# Access Compliance Report

## Public Rights-of-Way

### (Curb Ramps)

Intersection ID: 44453	Main Street: BAYVIEW_PY	Cross Street: RUMNEY_CT	Location: NE
ADA ID: DCF880B6B172	Ramp Type: PerpDiag	Initial Pass/Fail: Fail	Overall Compliance: No
Codes/Mitigation Info/Possible Solution			Severity Score: 10
Field Measurements/Component Compliance

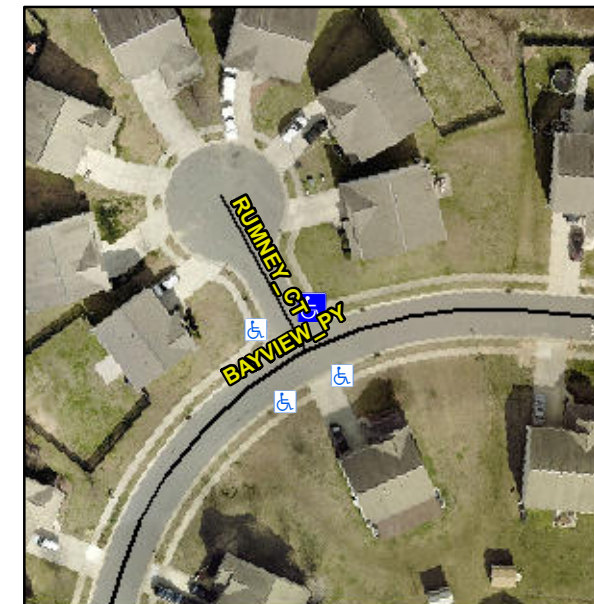
**Not Found, R304.5.1, R304.5.3**

Compliance	Description	Data	Compliance	Description	Data
N/A	Ramp Length (in)	48.0	Yes	Ramp Slope (%)	5.8
No	Ramp Width (in)	47.0	No	Ramp XSlope (%)	2.3
N/A	Flare Type LT	N/A	N/A	Flare Type RT	N/A
N/A	Flare Slope LT (%)	N/A	N/A	Flare Slope RT (%)	N/A
N/A	Flare Traversable LT?	N/A	N/A	Flare Traversable RT?	N/A
N/A	Landing Length (in)	N/A	N/A	DWS Provided?	N/A
N/A	Landing Width (in)	N/A	N/A	DWS Contrast?	N/A
N/A	Landing Slope (%)	N/A	N/A	DWS Length (in)	N/A
N/A	Landing X Slope (%)	N/A	N/A	DWS Full Width?	N/A
N/A	Landing Curb? (Y/N)	N/A	N/A	DWS Offset (in)	N/A
N/A	Shared Landing?	N/A			
N/A	Gutter Ponding?	N/A	N/A	Gutter Slope (%)	N/A
N/A	Gutter Lip Ht (in)	N/A	N/A	Gutter X Slope (%)	N/A
N/A	Painted X Walk1?	No	N/A	Painted X Walk2?	No
	X Walk 1 Direction	To W		X Walk 2 Direction	To S
N/A	X Walk 1 Width (in)	N/A	N/A	X Walk 2 Width (in)	N/A
	X Walk 1 Slope (%)	2.1		X Walk 2 Slope (%)	0.3
	X Walk 1 X Slope (%)	1.0		X Walk 2 X Slope (%)	1.0

**Remove & Replace Curb Ramp With Two New Directional Ramps or Equivalent.**
